Office Action Summary	Application No. 10/561,532	Applicant(s) DEKKER ET AL.	
	Examiner Michael B. Shingleton	Art Unit 2815

DETAILED ACTION

Above is Figure 4 of the instant application.

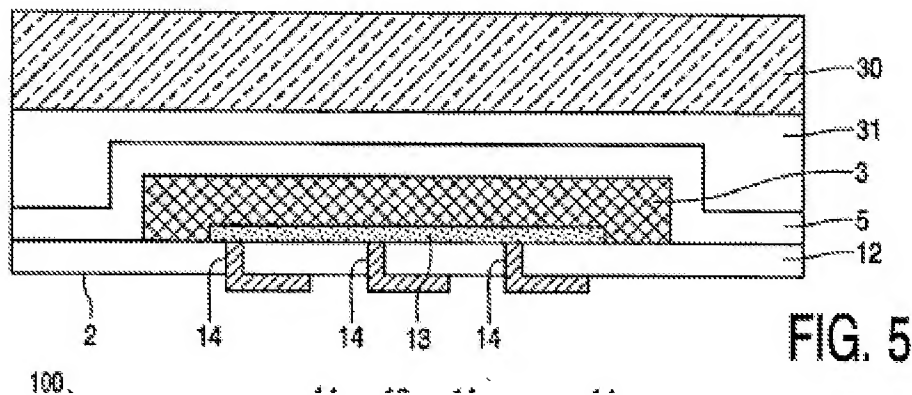
The specification clearly is not written in "full, clear, concise, and exact terms" as required by 35 USC 112 first paragraph because with the base layer 13 being covered by layer 3 and layer 12 such that no part of layer 13 is exposed as shown in Figure 4 how can the base layer 13 be grinded as required by the original disclosure??? Figure 5 showing the result after the grinding of the base layer 13 shows that base layer 13 is not grinded.
